**U.S. Department of Transportation
Federal Aviation Administration**

**Airworthiness Directive
Revision**

79-11-05 R1 MOONEY: Amendment 39-3480 as amended by Amendment 39-4050. Applies to Mooney M-18L S/N's 2 and up, M-18C S/N's 201 and up, M-18LA S/N's 100 through 200, M-18C55 S/N's 323 and up certificated in all categories.

Mooney Mite Model 18

FIG. 17

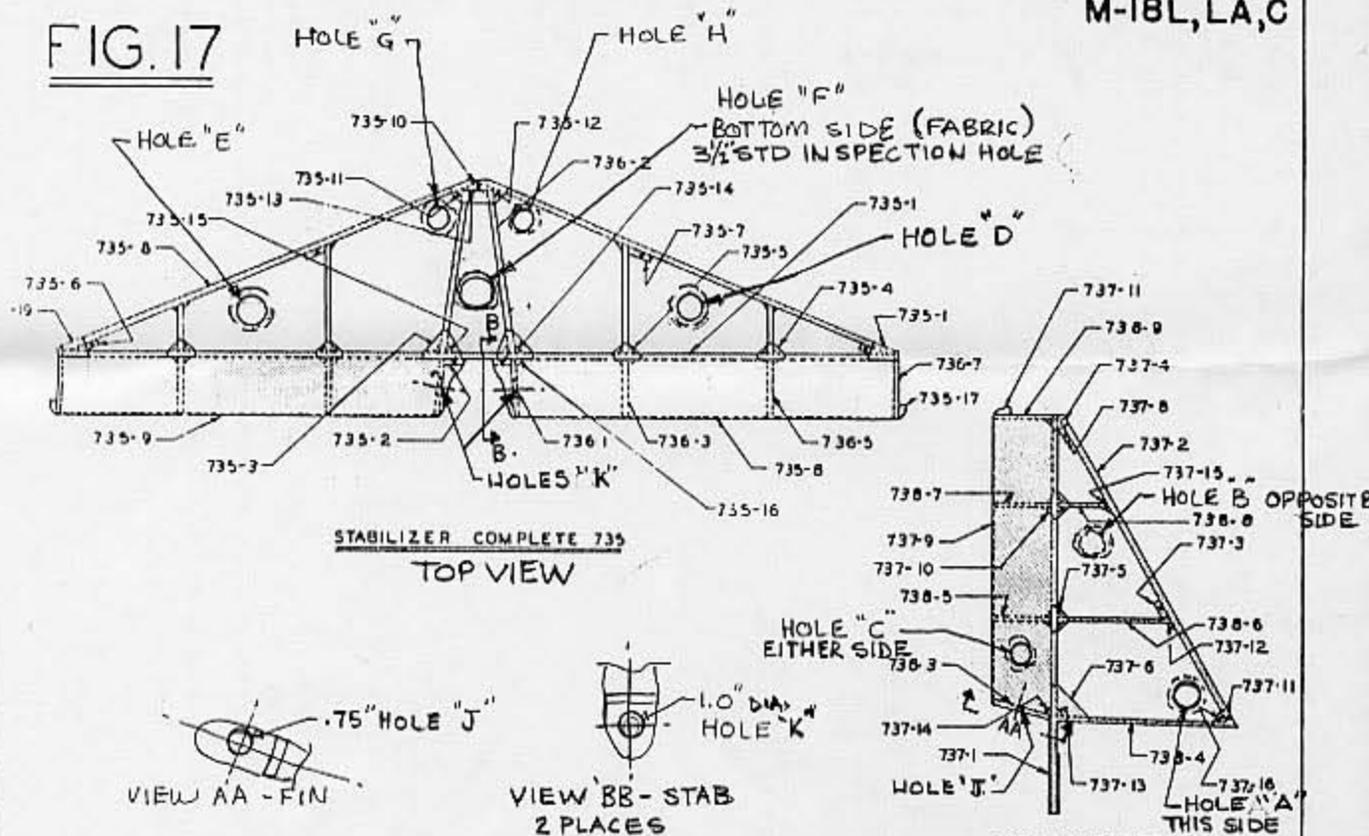
- A. The following modifications are acceptable as an alternate method of inspection compliance for using a borescope with Paragraphs (1), (2) & (3) of AD79-11-05R1 dated 27 Feb 1981. SEE:

- (a) Cut 2.00 inch diameter holes in approximately the locations as shown on stab & fin drawing.
- (b) Cut a 2.62 inch diameter plastic ring with a 2.00 inch diameter hole from a .025 inch thickness material.

- (e) Follow the procedures (b) through (d) above for holes "A" through "H", except for hole "F". All holes in stabilizer are located on bottom side only.

- (f) The holes shown in view AA and BB should remain open. If hole "K" is to be used for inspection purposes, hole "C" is not required or vice versa; it's optional.

- (g) NOTE: Hole "F" is already an existing inspection hole in the bottom side of stabilizer.
- (h) Holes in fin are placed on either side or as noted on the drawing.

FIG. 18

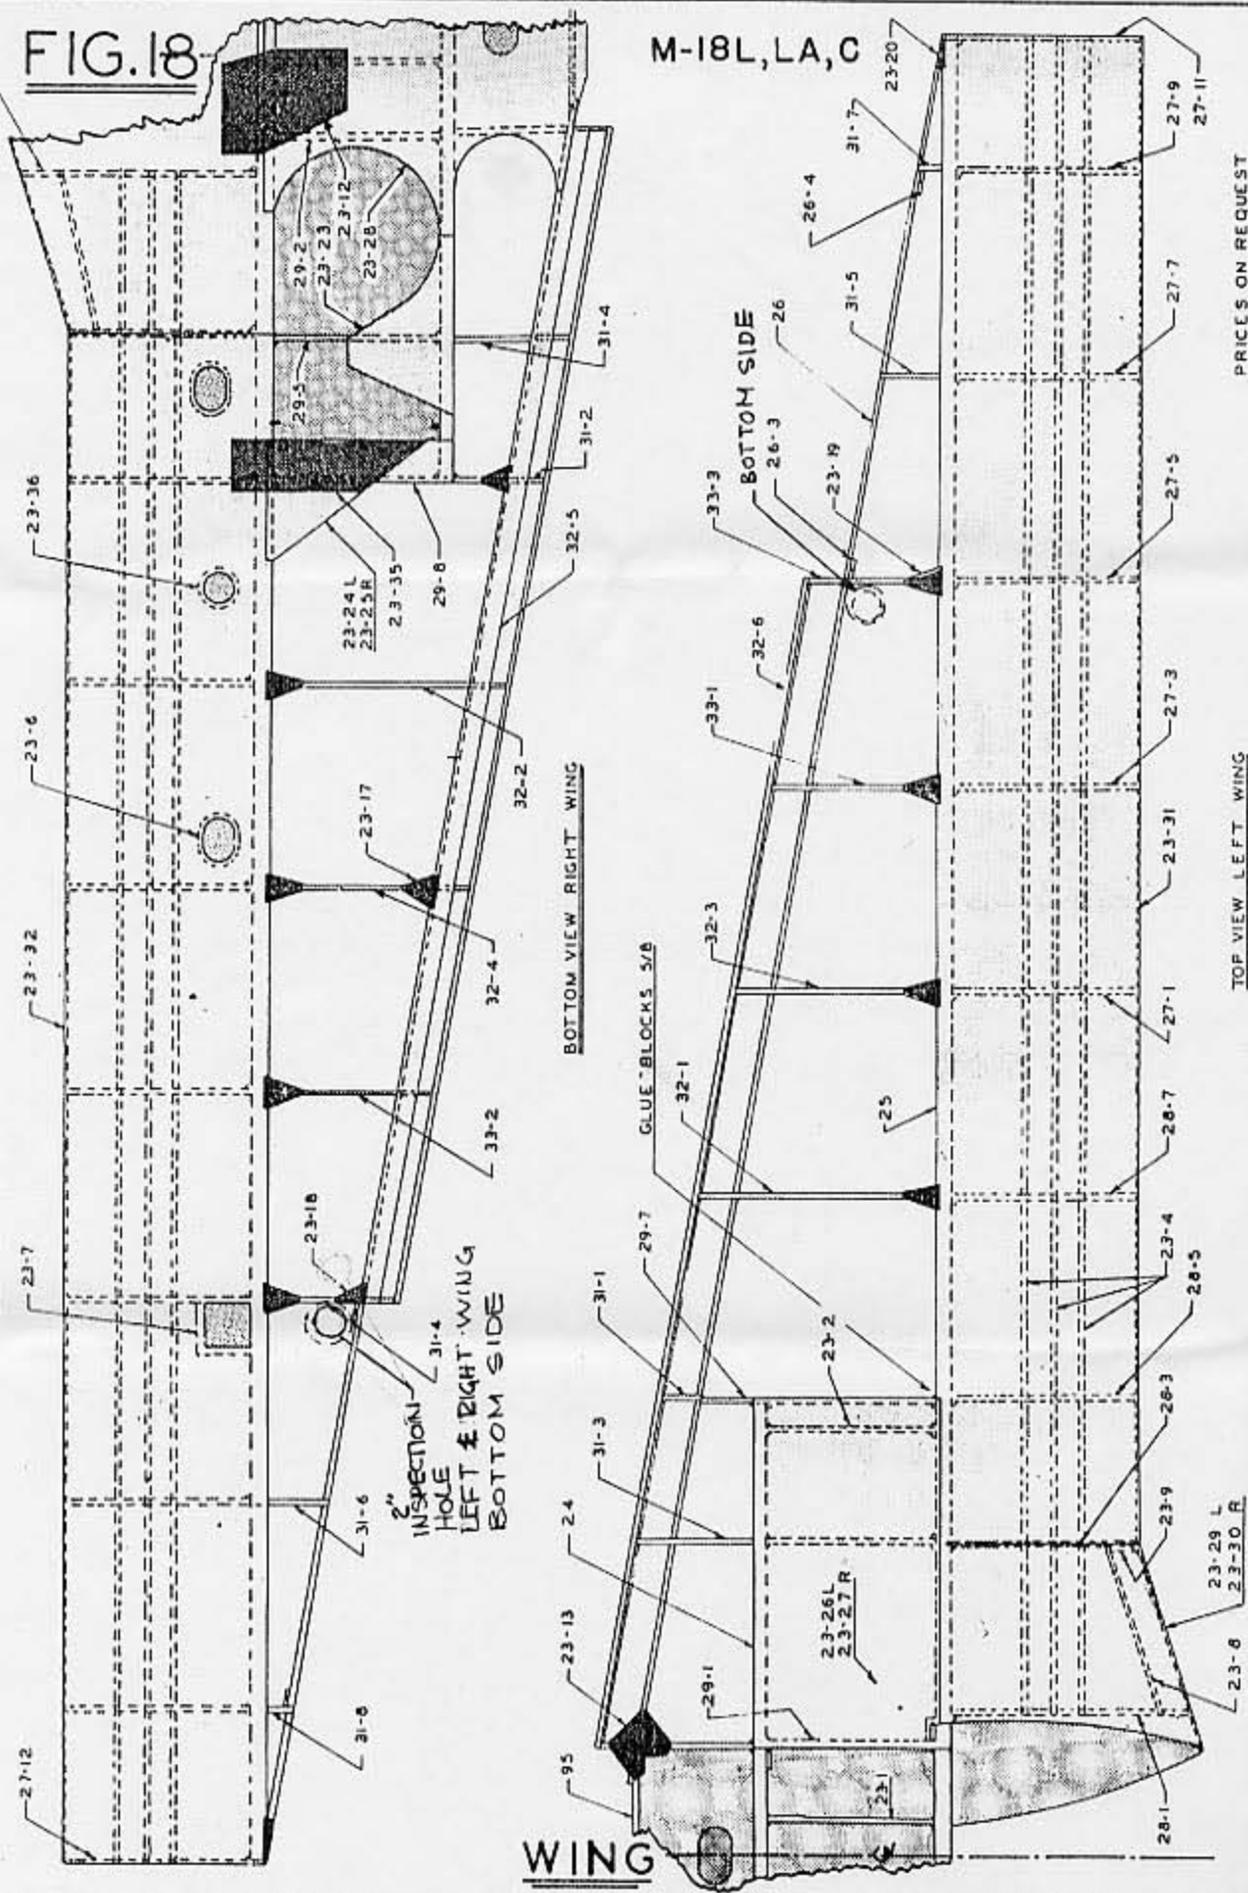
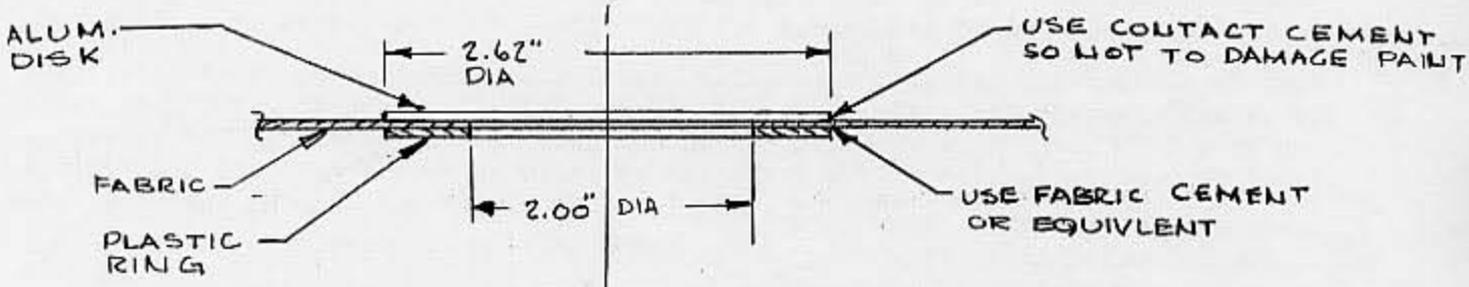
- B. The following method is an optional method of access in inspection compliance for Paragraph (4) of AD79-11-05 R1 dated 27 Feb 1951. SEE:

- (a) Cut 2.00 inch diameter holes in approximately the locations shown on the bottom side of the wing drawing.
- (b) Cut a 2.62 inch diameter plastic ring with a 2.00 inch diameter hole from a .025 inch thickness material.
- (c) Follow the same procedures (c) and (d) described for FIGURE17 stab & fin to complete the process.

TYPICAL INSTALLATION
SECTIONAL VIEW
OF INSPECTION HOLE

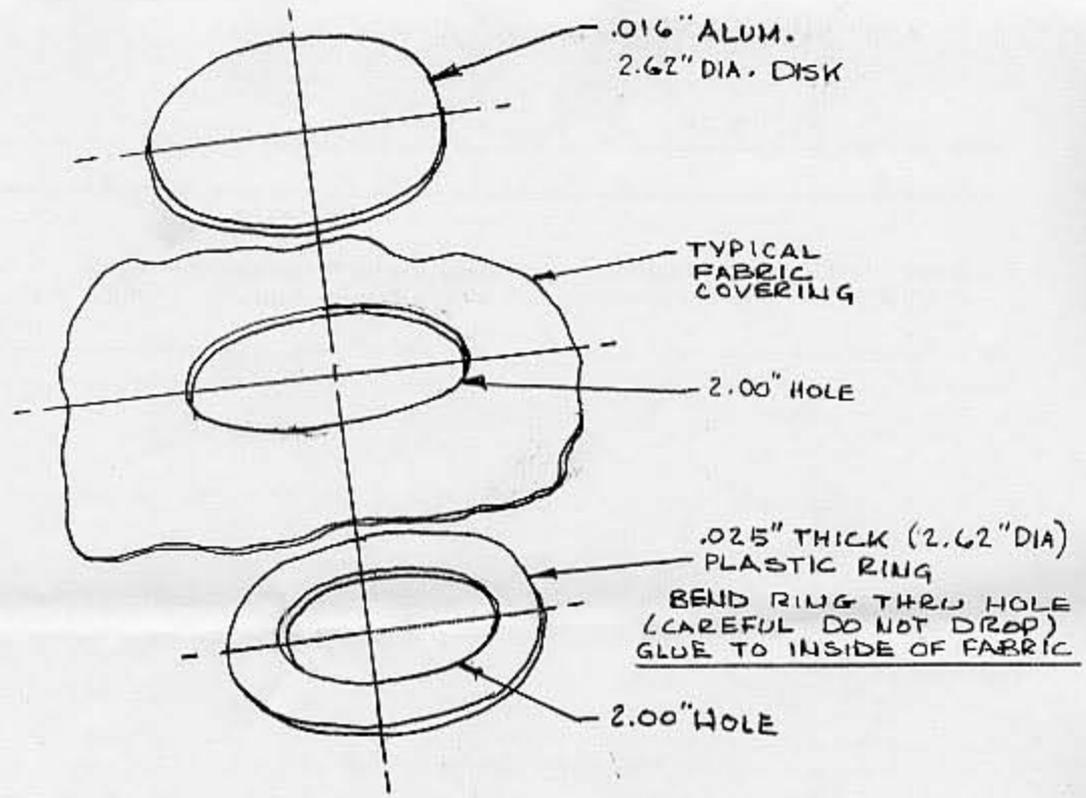
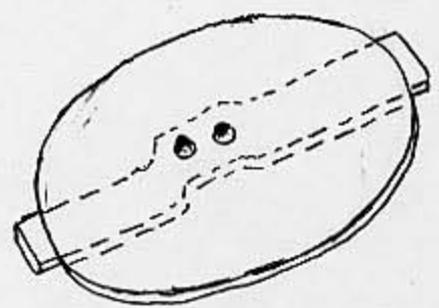
- (c) Insert plastic ring into 2.00 inch fabric hole and glue to inside. See "Typical Installation Of Inspection" drawing. Clip the plastic ring onto fabric with clothespins until dry. Take care not to drop ring inside in attempting to glue onto fabric.

- (d) Cut a 2.62 inch diameter aluminum disk, .016 inch thickness.
 - Paint disc with the same color as aircraft (one side only).
 - Apply contact cement to the edges of unpainted side of disc, ¼ inch wide of total circumference. This step is not required if using optional disc with clip.

NOTE: AS AN OPTION TO THE .016 PLAIN DISK SHOWN A CLIP CAN BE FABRICATED FROM THIN FLAT SPRING STEEL AND RIVETED TO DISK. SEE BELOW;
